## Product Change Notification / SYST-09AZKK894

PIC18F27/47/57Q84 Silicon Errata and Data Sheet Clarifications

Removed data sheet clarifications, updated data sheet revision to current revision, added silicon revision C0.

### 1.6.1 UART TXDE Signal May Go Low before the STOP Bit Has Been Entirely Transmitted

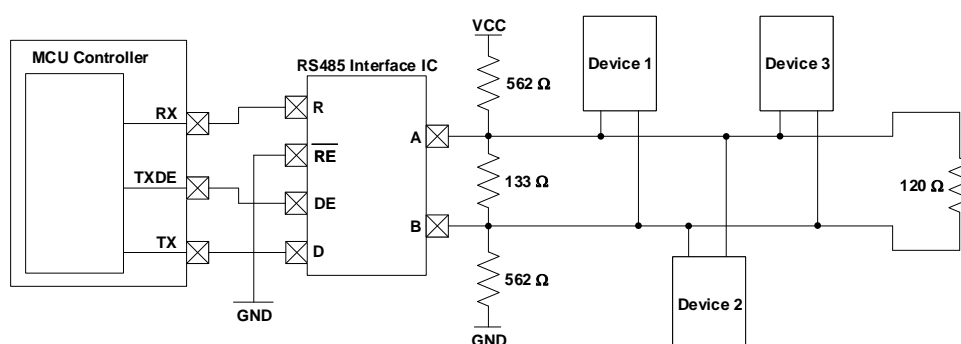
The UART Transmit Drive Enable (TXDE) signal could potentially transition into a low state before the UART STOP bit has been entirely transmitted due to the effects of parasitic capacitance on the TX line. In some applications, this could result in communication being prematurely terminated due to the TXDE bit going low before the STOP bit has had enough time to settle.

To ensure that the STOP bit settles into its final logic state before the TXDE signal transitions low, a biasing circuit can be implemented. A biasing circuit allows the TX line to either be driven high or low, rather than being left in a floating tri-state mode where prolonged rise or fall times could lead to communication being disrupted. This bias circuit should only be implemented on one end of the serial bus, and a termination resistor should be used on the other end. The figure below shows an example of a bias circuit that can be used to achieve this.

Please note that the resistor values used in this circuit are recommendations and that the actual resistor values required may vary based on the application.
